NNWSI CONCEPTUAL MODEL UPDATE

NNWSI Repository Project  
Subtask 1.4

**Conceptual Model Update  
Yucca Mountain Site**

**Contract No.: RS-NMS-85-009**

FIGURE 2-11  
POTENTIOMETRIC SURFACE OF THE  
HYDROGEOLOGIC STUDY AREA

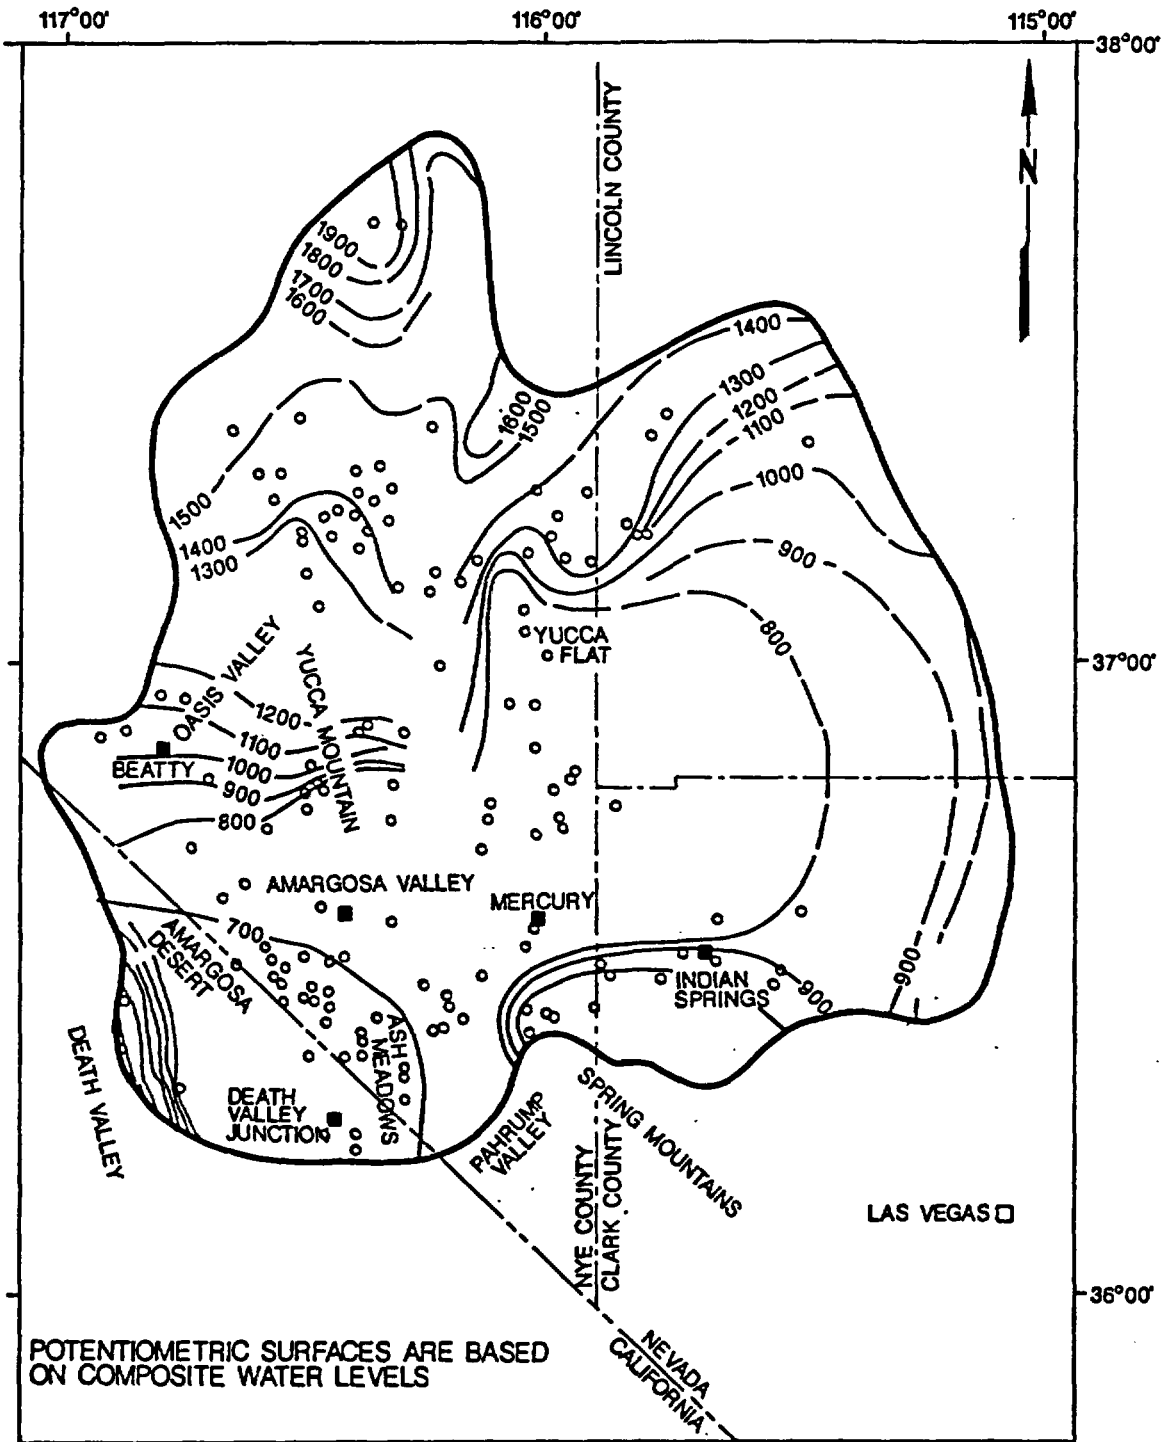
<sup>6</sup>USGS Comment - Potentiometric Contours (p. 133)

It should be stated that the hydraulic properties of the hydrogeologic units are unknown over large areas of the study area. In areas of no information, hydraulic properties may also vary greatly and may affect the concept of groundwater flow. The USGS disagrees with the interpretation of potentiometric surface contours drawn on Figure 2-11. The contours have no control (wells) for an area of 80 by 100 kilometers yet potentiometric contours have been approximated through the area whereas in areas of control, some contours have been omitted. What basis is used to draw the contours in the area of no control? The contours in areas of no control should be omitted from the figure.

FIGURE 2-13  
RICE'S 1984 STUDY AREA

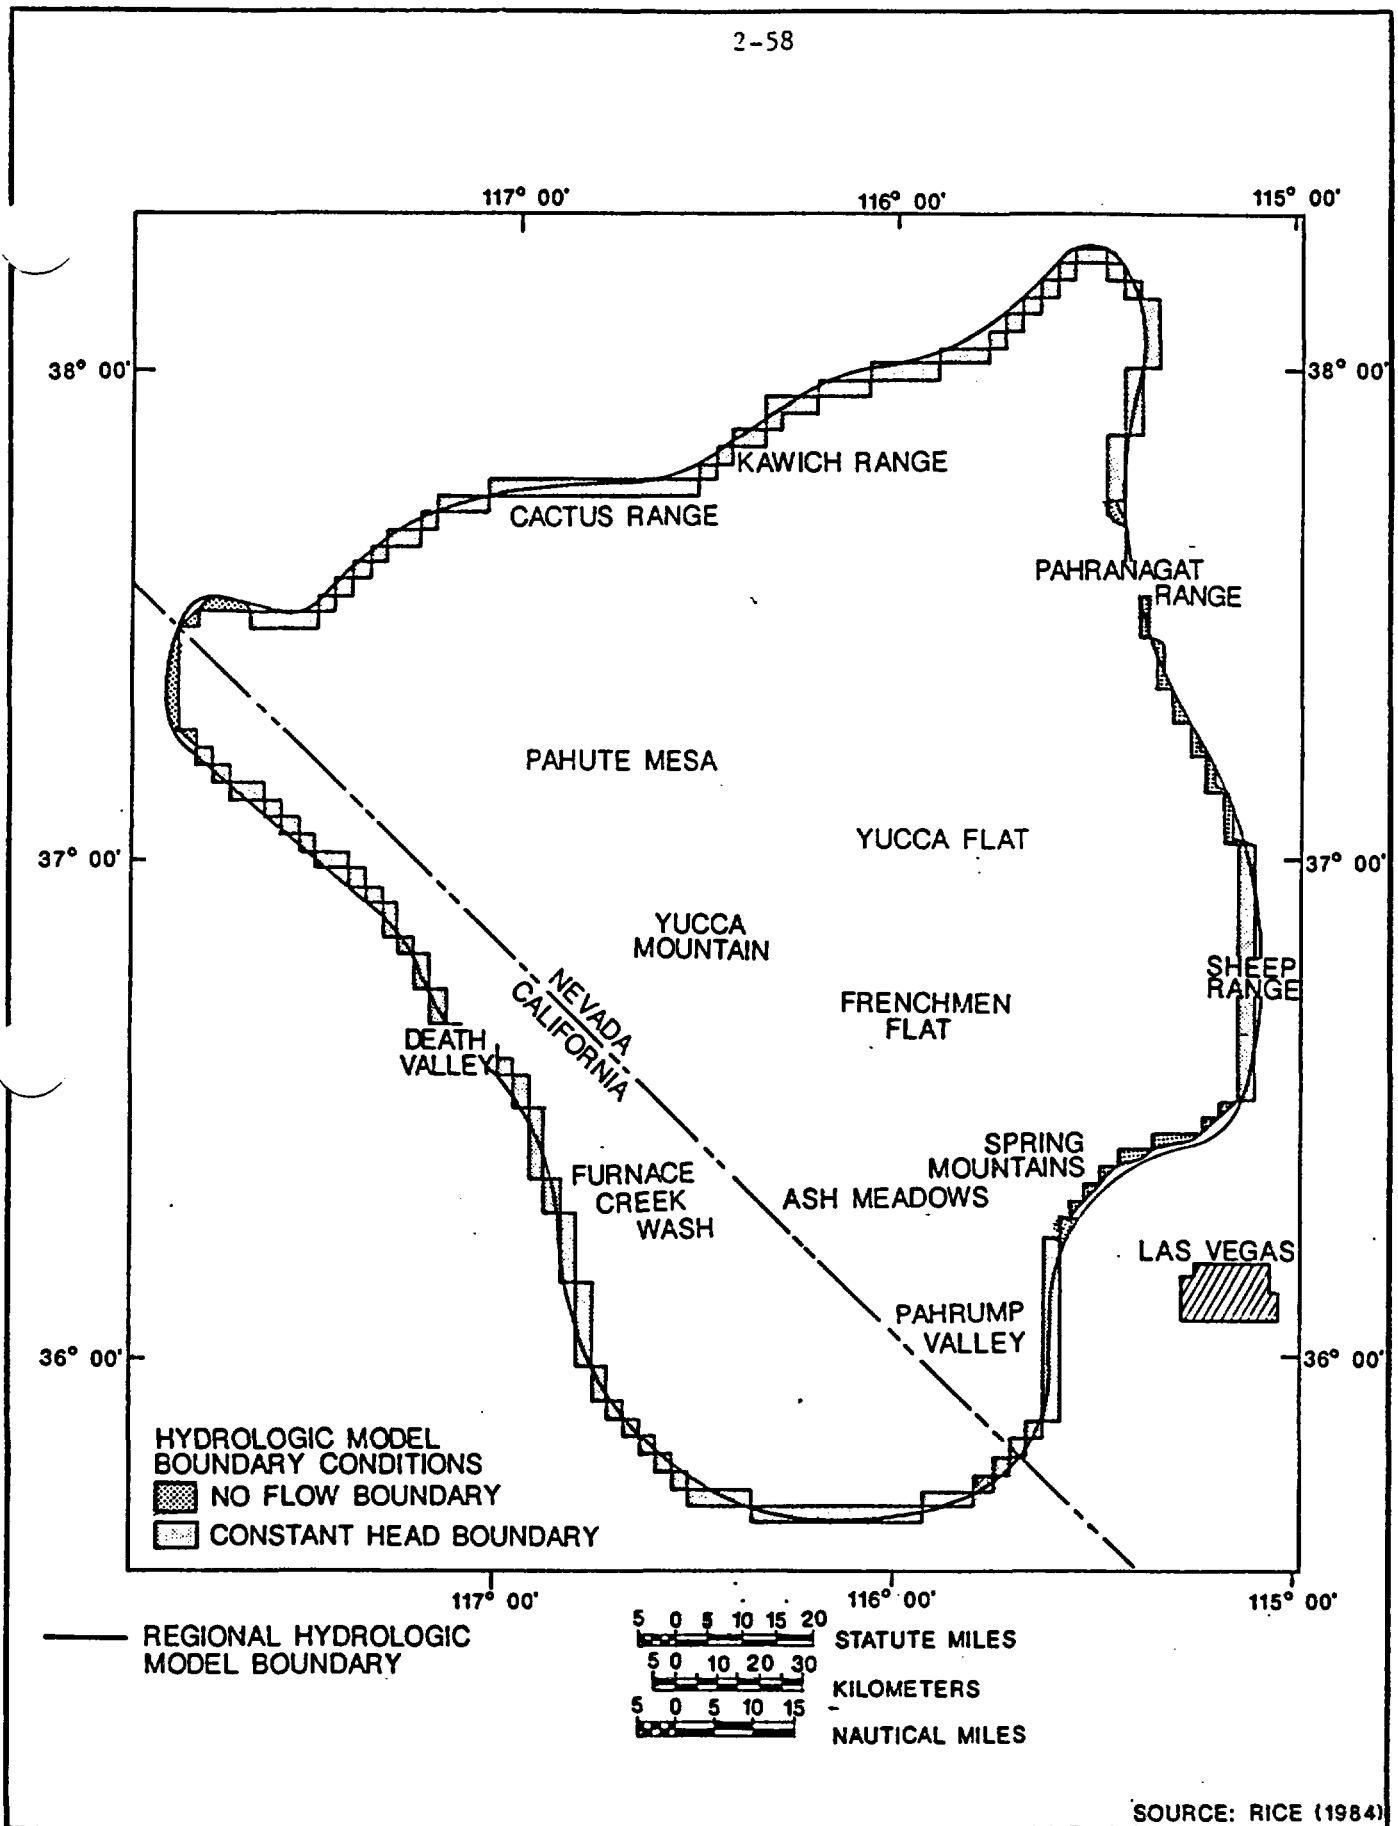
<sup>13</sup>USGS Comment - Studies to Provide a Description of the Regional System  
(p. 152)

On what basis is the boundary of the subregional model drawn?

FIGURE 2-18  
 SENSITIVITY OF CALCULATED TRANSMISSIVITY  
 NEAR YUCCA MOUNTAIN  
 TO INCREASED FLUX VALUES

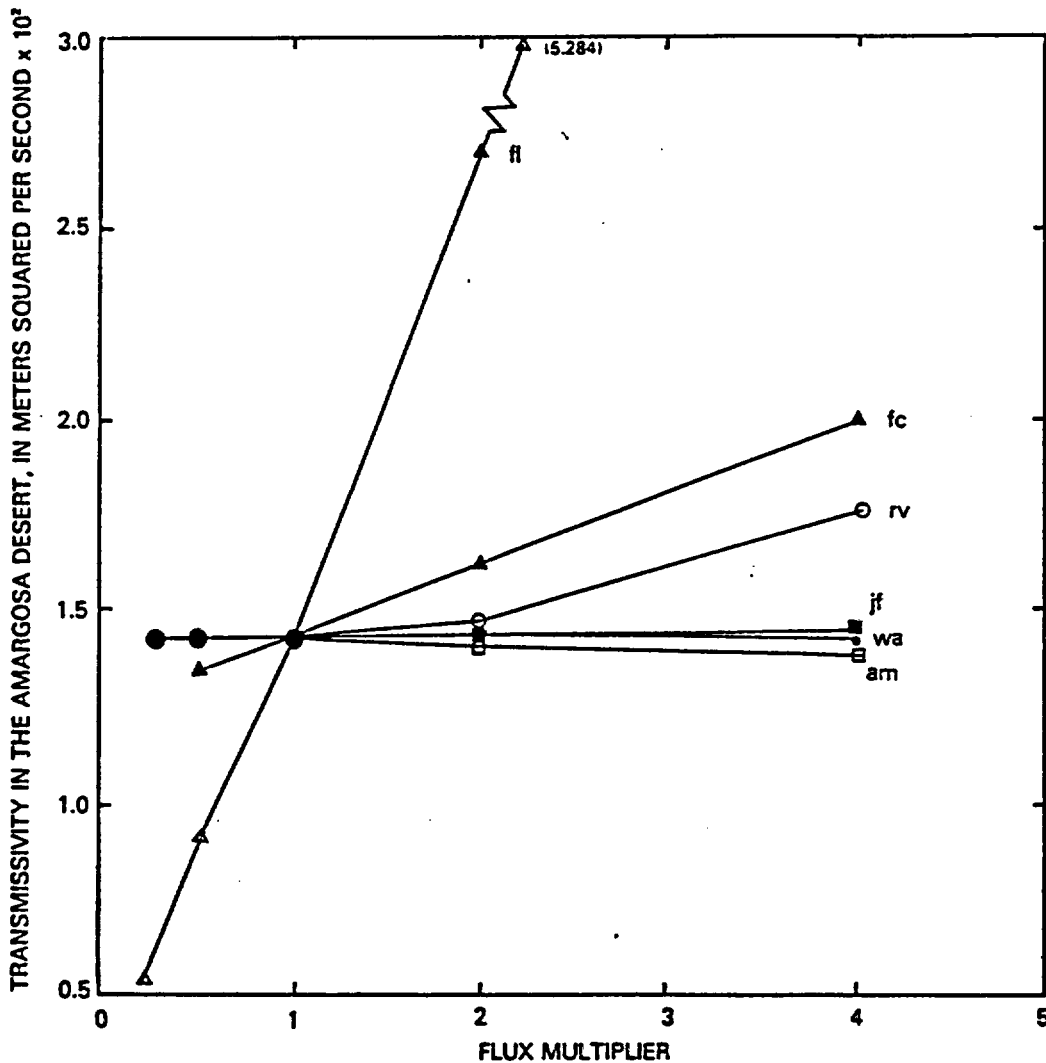
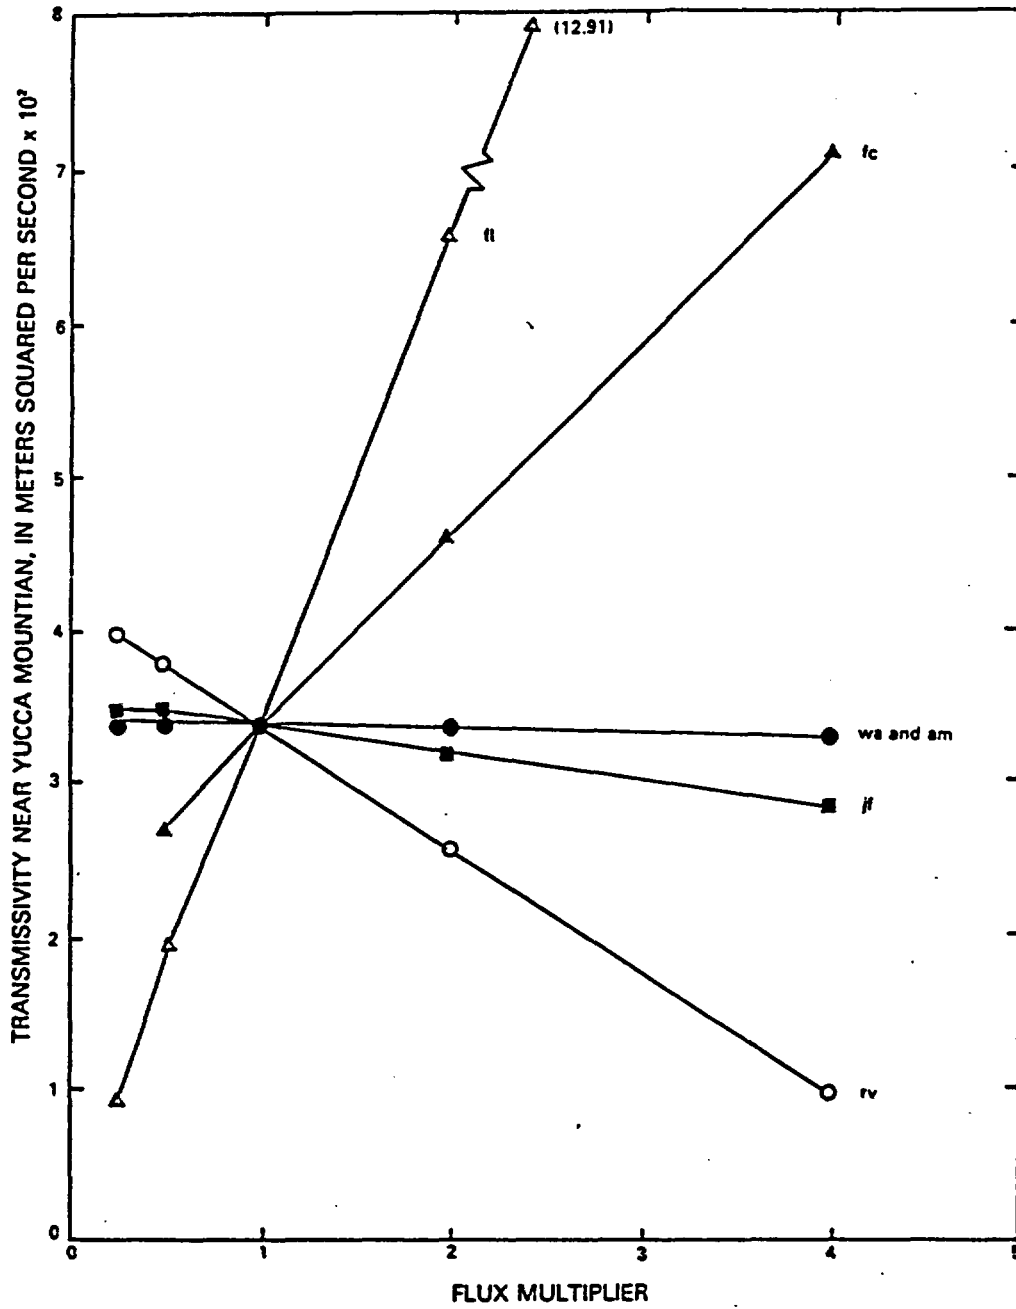
<sup>14</sup>WWL Comment - Transmissivity Values at Yucca Mountain

How can a discharge flux located downgradient from Yucca Mountain have such a great impact on estimated transmissivity values for Yucca Mountain (Figure 2-17)? Why was the discharge at Franklin Lake Playa allowed to vary if data on its discharge is well understood?
